ADDENDUM

to the **Final Environmental Impact Report**
Bidwell-Sacramento River State Park Habitat Restoration
and Outdoor Recreation Facilities Development

Prepared for the Central Valley Flood Protection Board
Evidentiary Hearing on the Encroachment Permit
Application for Riparian Habitat Restoration on the Singh
Unit of the Bidwell-Sacramento River State Park

January 2011

Figure 8. Velocity Differential – Restoration to Existing

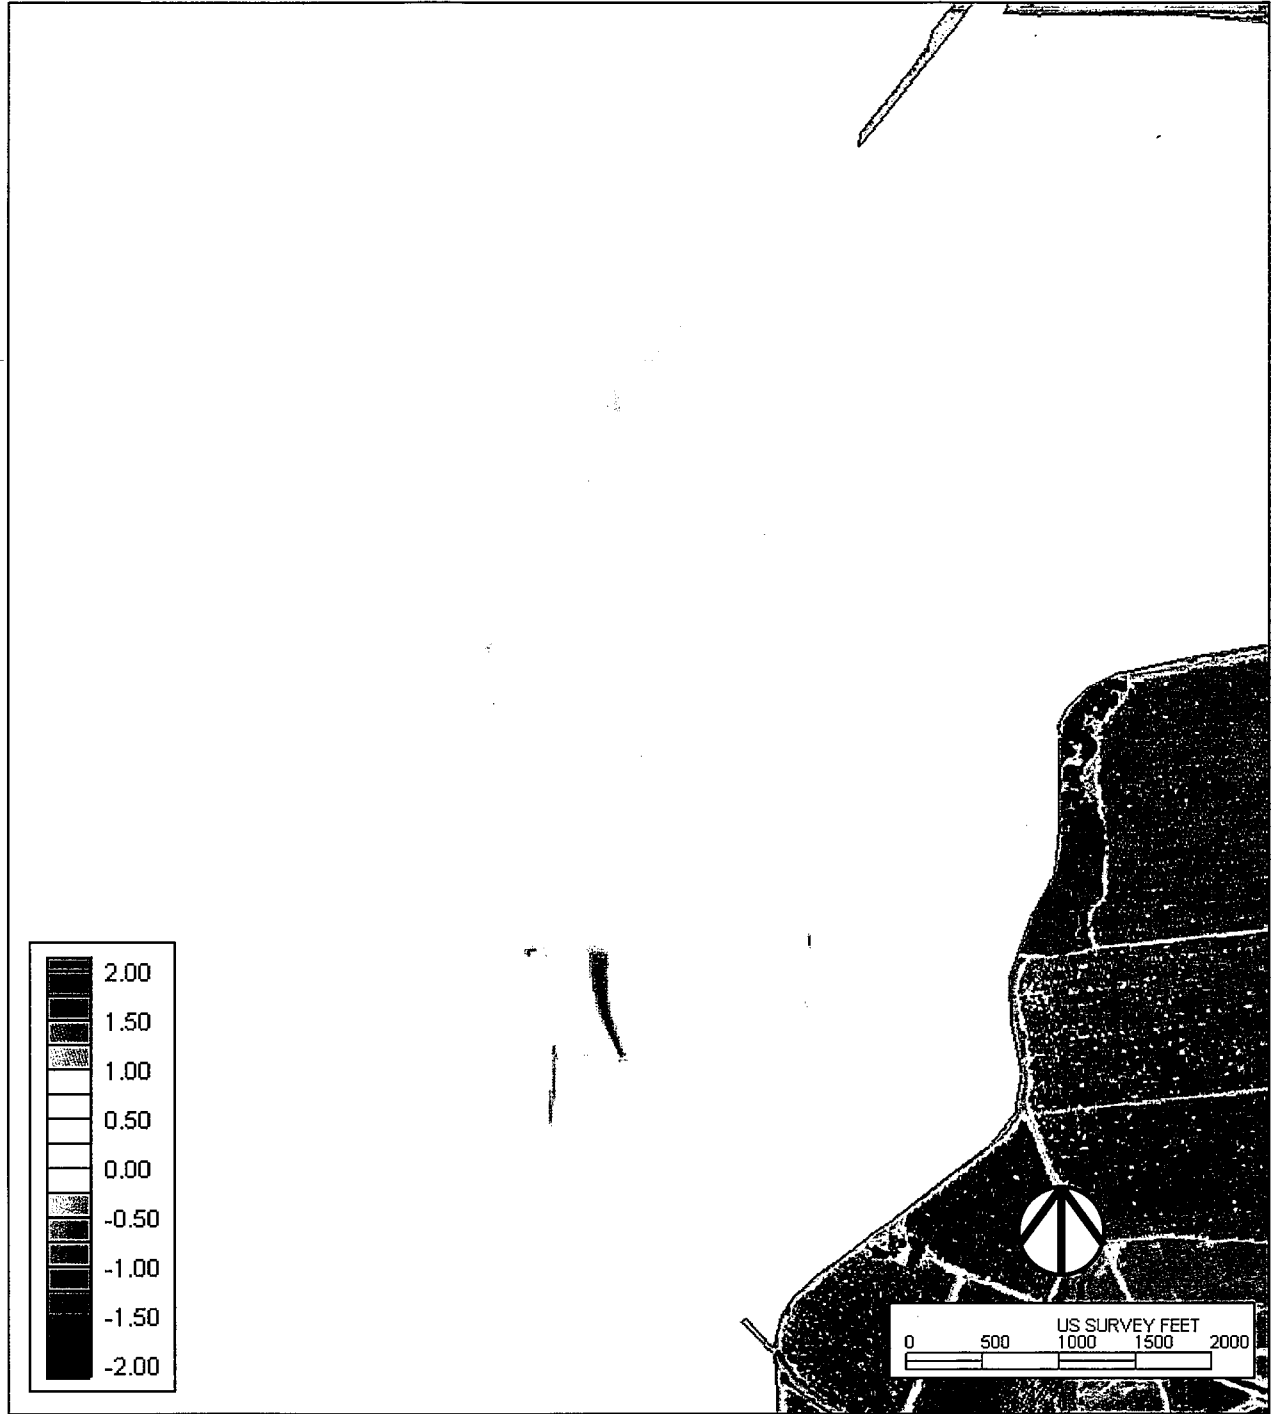
The velocity contours for the existing condition and the with-project condition are shown in **Figures 6** and **7**, respectively. The velocity differential plot is shown in **Figure 8**. The velocity differential equals the existing condition values subtracting from the with-project condition values. The velocity contours show that the velocity is between 0.0 ft/s and 3.5 ft/s in the project areas for both the existing condition and the with-project condition.

For the with-project condition, the land use change causes slight velocity increases. The largest velocity increase is 2.0 ft/s and is located in the meadow flow through passage in the Singh property. The existing velocity in that area is roughly 1.0 ft/s, and as long as the passageway remains vegetated, this increase should not have any harmful effects. There are increases adjacent to Mud Creek of up to 0.5 ft/s (from 0.5 ft/s to 1.0 ft/s). The grass buffers cause an increase on the west side of the properties, with the greatest increase being 1.2 ft/s (from 1.0 ft/s to 2.2 ft/s) at the southern end of the Nicolaus Community. The removal of the berm from the Singh property causes an increase in that area of up to 0.7 ft/s (from 0.7 ft/s to 1.4 ft/s) and also slightly reduces the velocity on the east bank of the Sacramento River adjacent to the site. Velocity vector plots for existing and with project condition are shown in **Figures 9** and **10**. These do not show any significant change in the flow path of the river and floodplain.

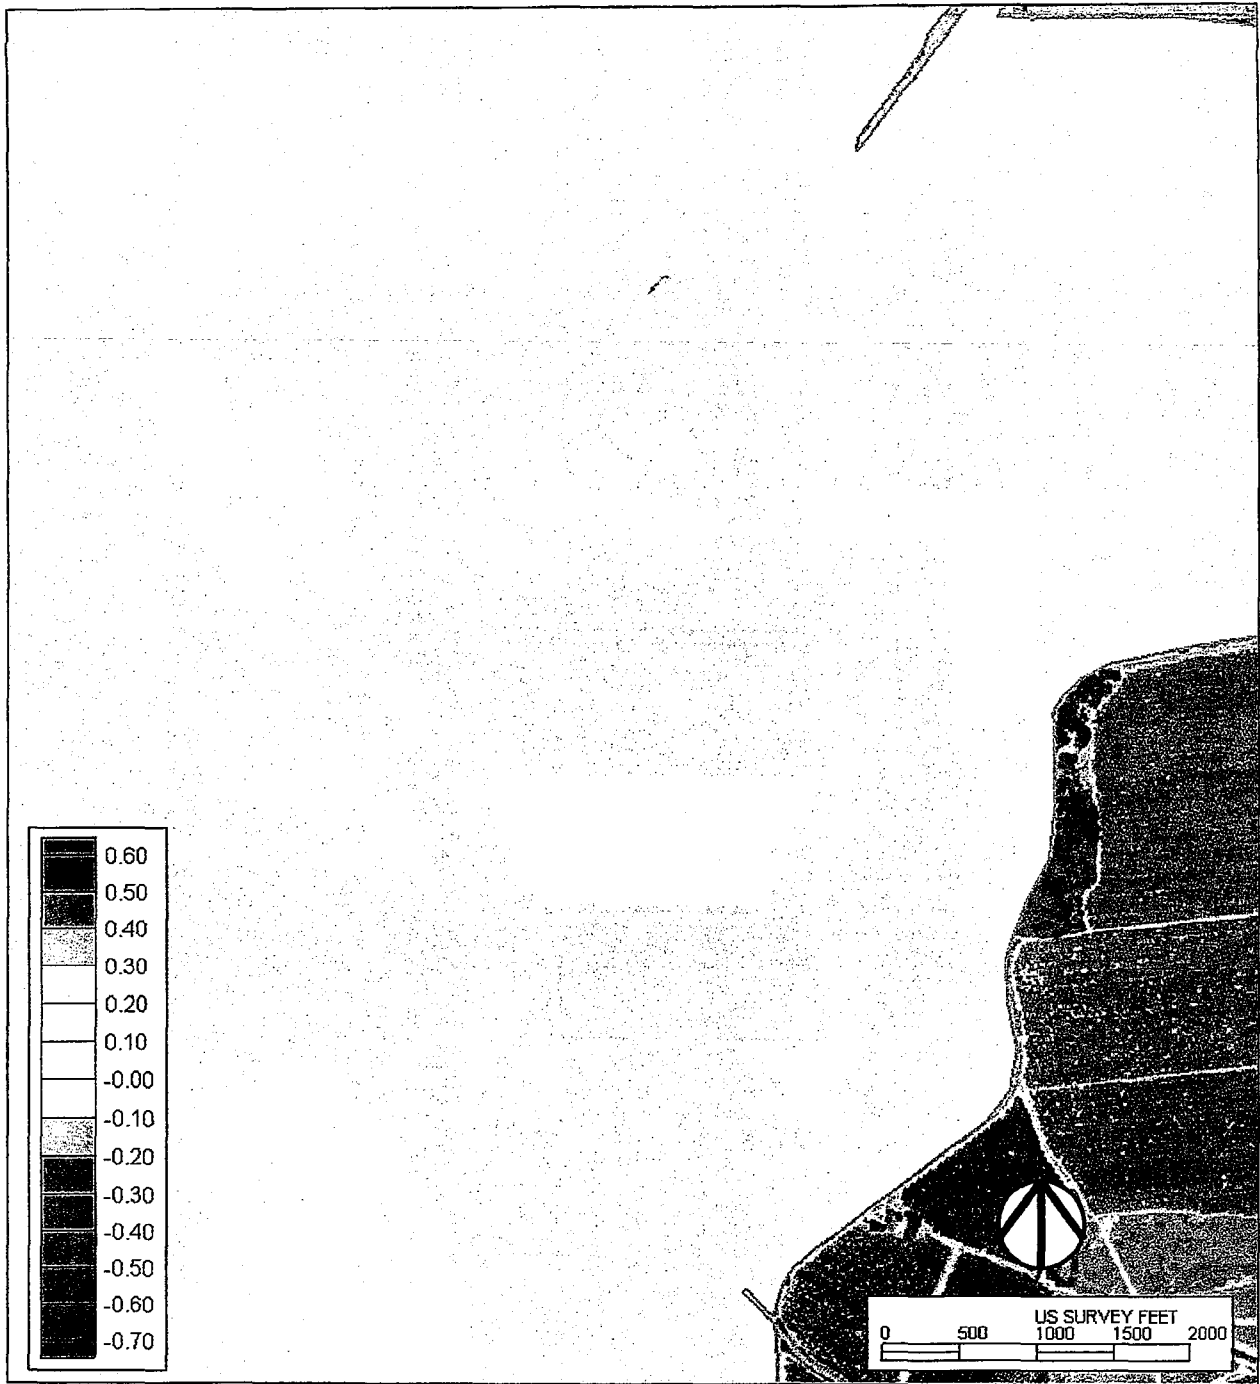
The largest change is within the grassland area of the Singh Unit and the differential velocity figure shows an increase of up to 2 fps for this area. This makes the new velocity over the grassed area approximately 3 fps which is not considered erosive for grass cover.

Issues of sedimentation and erosion are directly related to floodplain velocities, therefore any changes to the existing erosion and sedimentation patterns would be the direct result of changes in velocity and, to a lesser extent, flow depths. A review of the differential velocities plot shows negligible change on any of the adjoining parcels. There are some changes within the Singh parcel primarily within the grassed corridor where there is an increase of +2.0 fps (total velocity of approximately 3.0 fps).

Water Depth Differential – Restoration to Existing (Figure 8, p.10, Ayres, 2008)

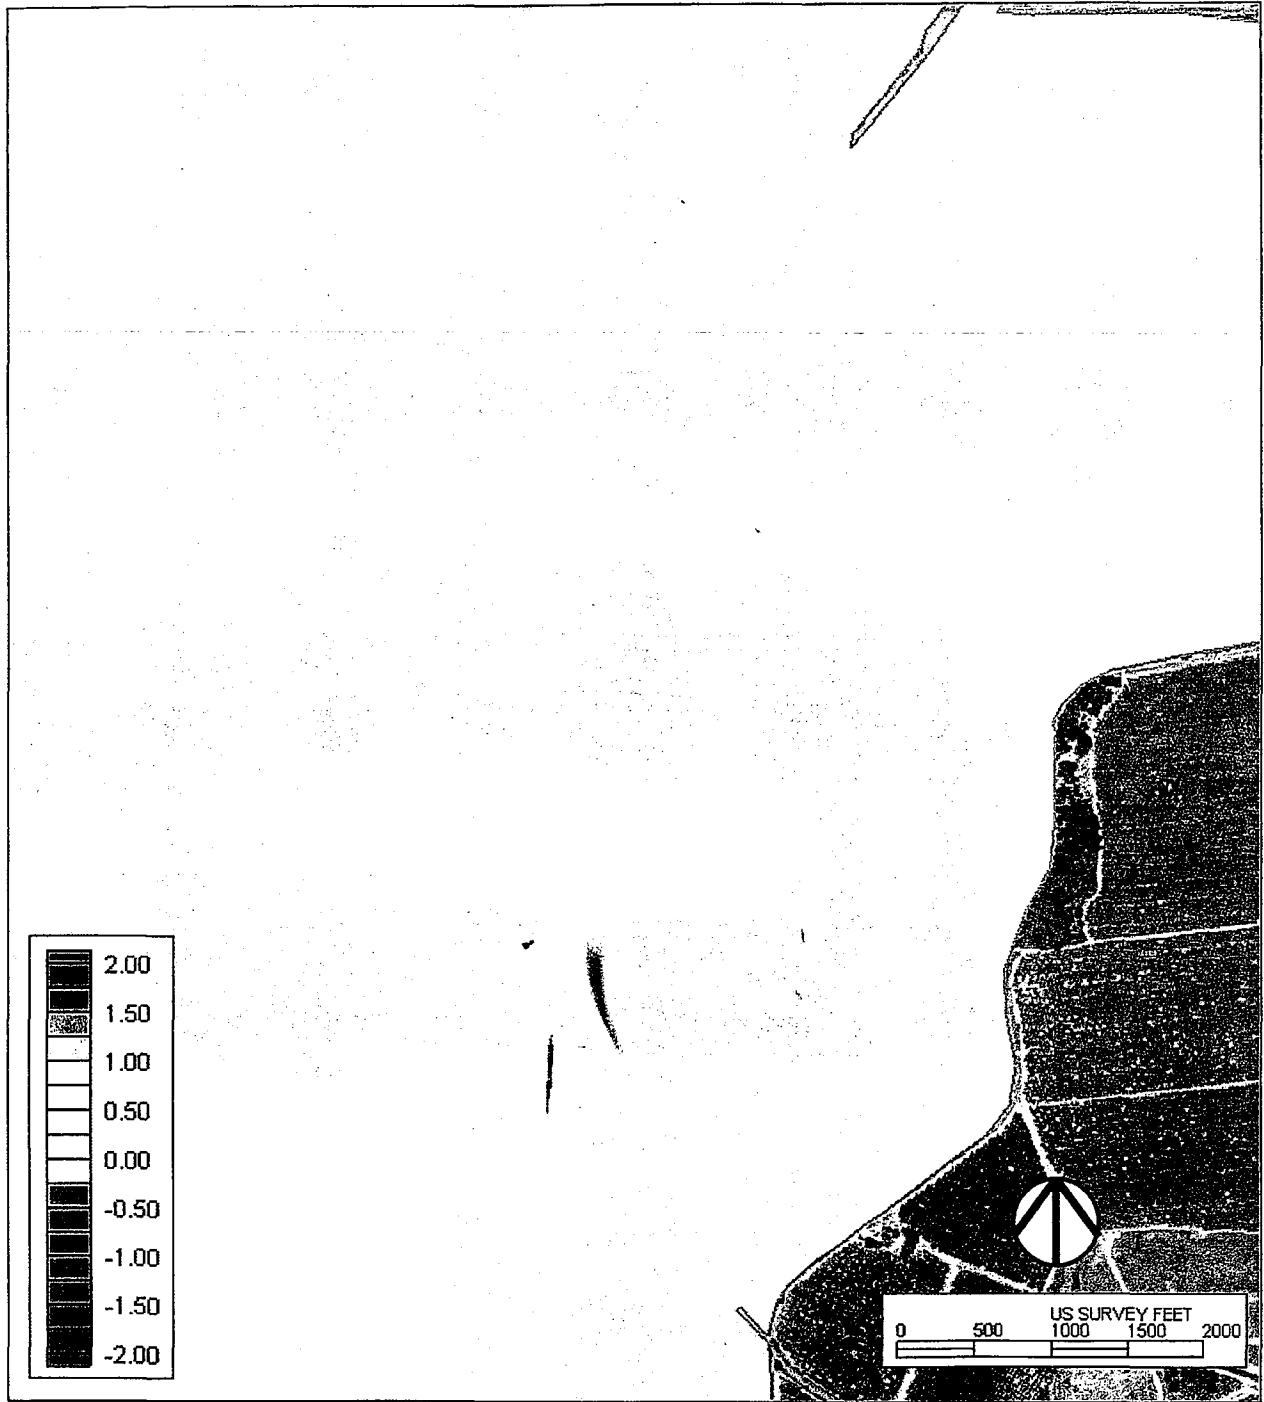
For the most part, existing velocities within this floodplain area are less than 2 fps and in the existing condition some areas of deposition are expected to occur. This will remain the same for the proposed plan.

There are no measurable changes in flood depth on the floodplain for the before and after conditions, so no changes are expected in sediment transport in this area in relationship to flow depth.
